Our Ref: 152-2025

Re: Submission on Notice of Direct Planning Application to An Coimisiún Pleanála in respect of a Strategic Infrastructure Development in County Galway – Cashla Peaker Plant, Rathmorrissey and Pollnagroagh, Co. Galway.

Past Flood Event Local Area Summary Report

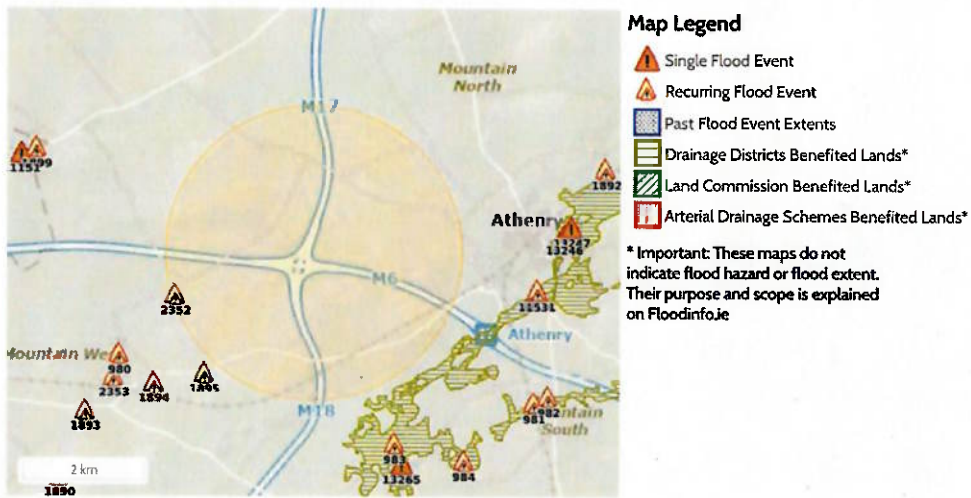
Another important point to note is that since the submission of this planning application updates have been ongoing on floodinfo.ie which include the surrounding area of the proposed development. A print out is attached to this report entitled “Past Flood Event Local Area Summary Report” which summarises all past flood events within 2.5 kilometres of the map centre.

Taking the above information into consideration the comment “Since there are no available flood maps, based on the map viewer, there is no flooding indicated at the proposed site” cannot be taken as factual due to the recent updates on floodinfo.ie and therefore a thorough and rigorous local flood risk analysis should be carried out at the site in question in relation to the proposed development.
